# UNITED STATES PATENT AND TRADEMARK OFFICE

APPLICATION NO.	FILING DATE	FIRST NAMED INVENTOR	ATTORNEY DOCKET NO.	CONFIRMATION NO.
10/596,694	06/20/2007	Angelo D'Arrigo	78857.105667	9542
86528	7590	04/14/2010		
King & Spalding LLP 401 Congress Avenue Suite 3200 Austin, TX 78701			EXAMINER GORDON, BRYAN P	
			ART UNIT 2837	PAPER NUMBER
			NOTIFICATION DATE 04/14/2010	DELIVERY MODE ELECTRONIC

### Office Action Summary

## DETAILED ACTION

**Figure A**

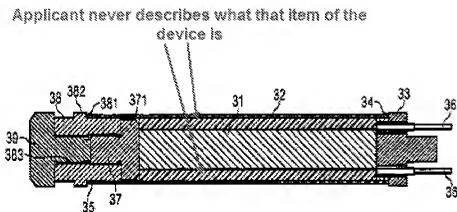
1. The drawings are objected of Figure A as shown below

2. Perhaps an explanation of what the items pointed to in the Figure could help in the prosecution of the case. Corrected drawing sheets in compliance with 37 CFR 1.121(d) are required in reply to the Office action to avoid abandonment of the application. Any amended replacement drawing sheet should include all of the figures appearing on the immediate prior version of the sheet, even if only one figure is being amended. The figure or figure number of an amended drawing should not be labeled as "amended." If a drawing figure is to be canceled, the appropriate figure must be removed from the replacement sheet, and where necessary, the remaining figures must be renumbered and appropriate changes made to the brief description of the several views of the drawings for consistency. Additional replacement sheets may be necessary to show the renumbering of the remaining figures. Each drawing sheet submitted after

**Figure B**

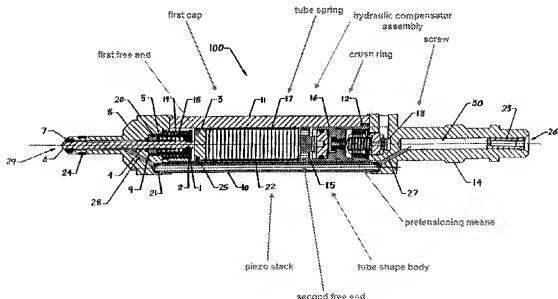
9. Considering claim 1, Shen (Figure B) teaches a piezoelectric actuator unit comprising: a tube spring (17); a piezoelectric actuator (22), that is inserted into the tube spring, a first cap (3), that is connected to the tube spring at a first free end (See Figure A above) of the tube spring and which is adjoined by the piezoelectric actuator (22), a tube-shaped body (15) that is connected to the tube spring by joining and is arranged in the area of a second free end (see Figure A), and a means for pretensioning the piezoelectric actuator after the tube spring (17) is connected to the first cap (3) and the tube-shaped body (15) (col. 3 lines 7-15, the device is already together therefore all the parts are connected) the means for pretensioning being supported by the tube-shaped body (col. 5 lines 52-54), and pretensions the piezoelectric actuator (col. 5 lines 49-57) by physically compressing the piezoelectric actuator (22) but not the tube spring.

10. Considering claims 4 and 13, Shen (Figure B) teaches a thread in the tube-shaped body and wherein the pretensioning means is a screw (13) that is screwed into the thread.

11. Considering claim 10, Shen (Figures B) Shen (Figure B) teaches a piezoelectric actuator unit comprising: a tube spring (17); a piezoelectric actuator (22), that is inserted into the tube spring, a first cap (3), that is connected to the tube spring at a first free end (See Figure A above) of the tube spring and which is adjoined by the piezoelectric actuator (22), a tube-shaped body (15) that is connected to the tube spring by joining and is arranged in the area of a second free end (see Figure A), and a means for pretensioning the piezoelectric actuator after the tube spring (17) is connected to the

Figure C

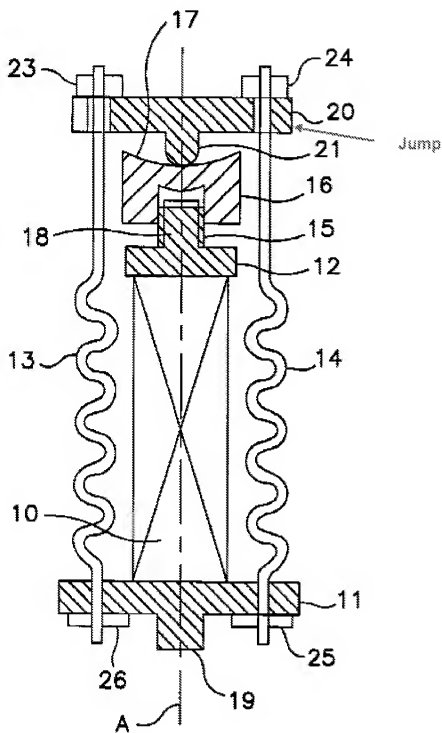
18. Considering claims 6 and 15, Mattes (Figure C) teaches the tube-shape body has a jump in its diameter on its outer circumference.
